# Erratum to: Structural and Thermoelectric Properties of Nanocrystalline Bismuth Telluride Thin Films Under Compressive and Tensile Strain

## ERRATUM TO: Journal of ELECTRONIC MATERIALS DOI 10.1007/s11664-014-3496-4

Fig. 5. (a) Electrical conductivity, (b) Seebeck coefficient, and (c) power factor of bismuth telluride thin films as a function of applied strain.

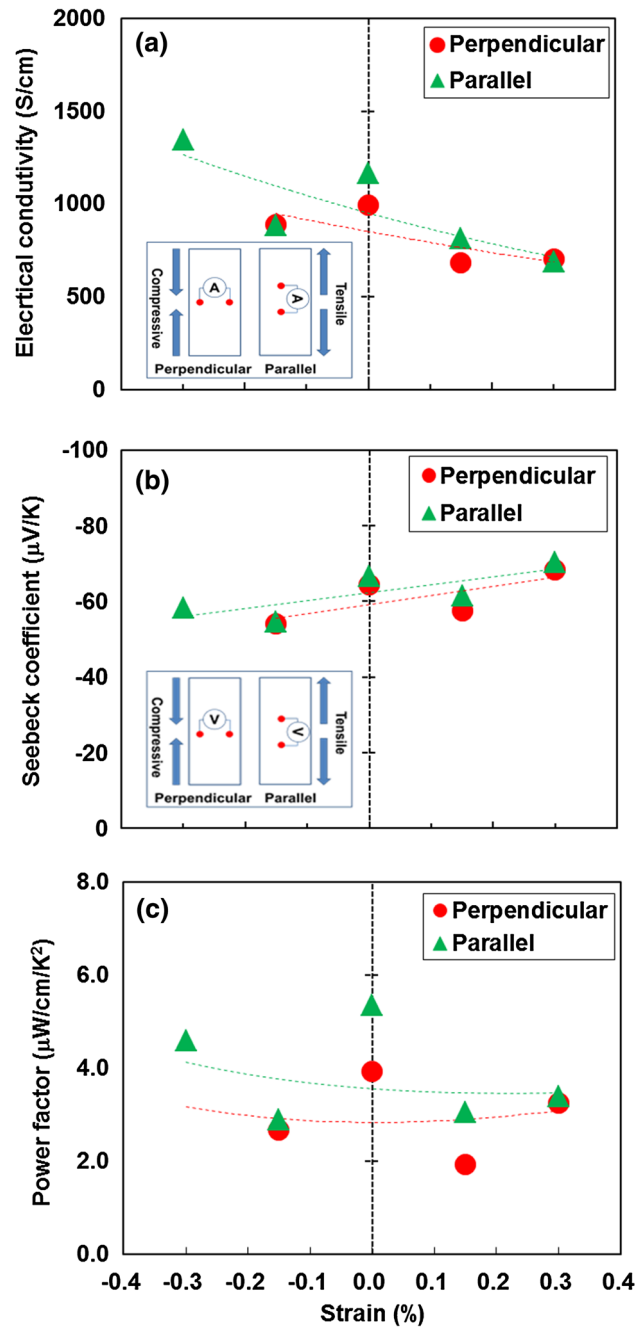
1. Figure 5 is corrected as shown in this erratum.
2. Due to this change, the relationship between the direction of strain and the in-plane thermoelectric properties becomes opposite trends, presenting in section of Abstract, Thermoelectric Properties of Strained Bismuth Telluride Thin Films, and Conclusion.
